**ROCKFORD BOARD OF EDUCATION
INVITATION FOR BID ON SUPPLIES, MATERIALS, EQUIPMENT OR SERVICES
FOR SCHOOL DISTRICT NO. 205
ROCKFORD, ILLINOIS**

IFB No. **16-48 Brookview Elementary School Additions and Renovations**

RE: **ADDENDUM NO. 2**

Project: **16-48 Brookview Elementary School Addition Project**
Project Number: IFB No. 16-48

FS101E

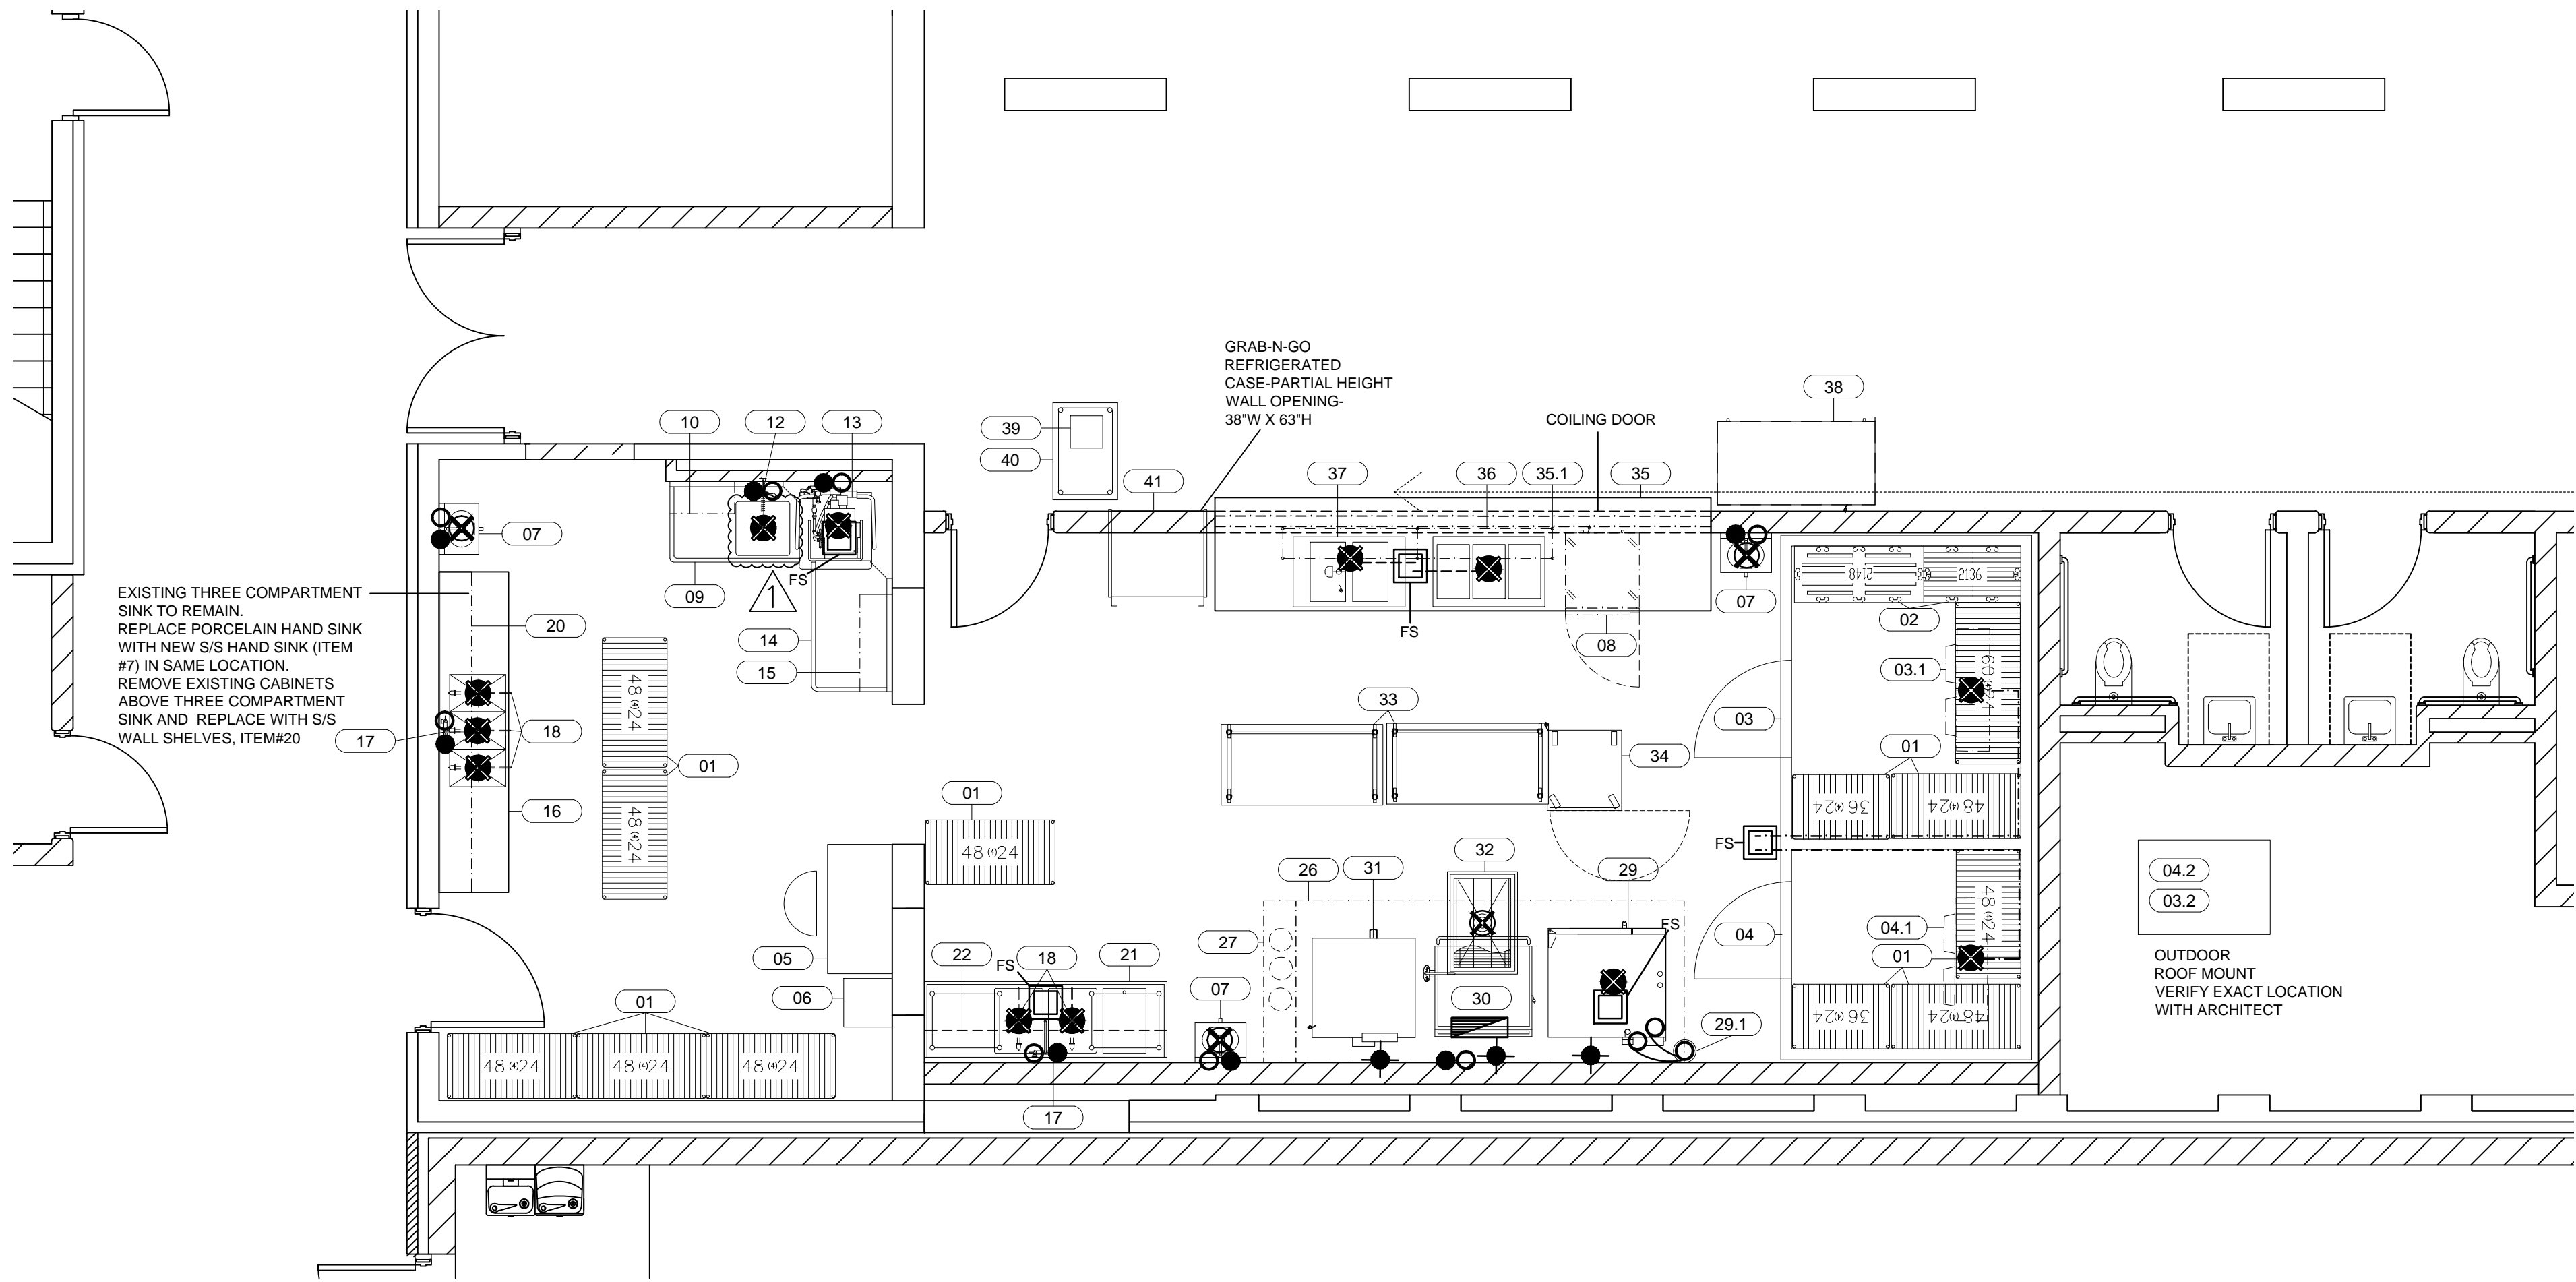
1. Revised Section: 114000 Food Service Equipment Specification Clarification Items
This Section Noted as Addendum #2 Dated 03-31-2016.
2. See attached Revised sheets FS101, FS101E, FS101M & FS101SC

- a) Section: 114000 Food Service Equipment Specification Clarification Items
This Section Noted as Addendum #2 Dated 03-31-2016.
- b) See attached Revised sheets FS101, FS101E, FS101M & FS101SC
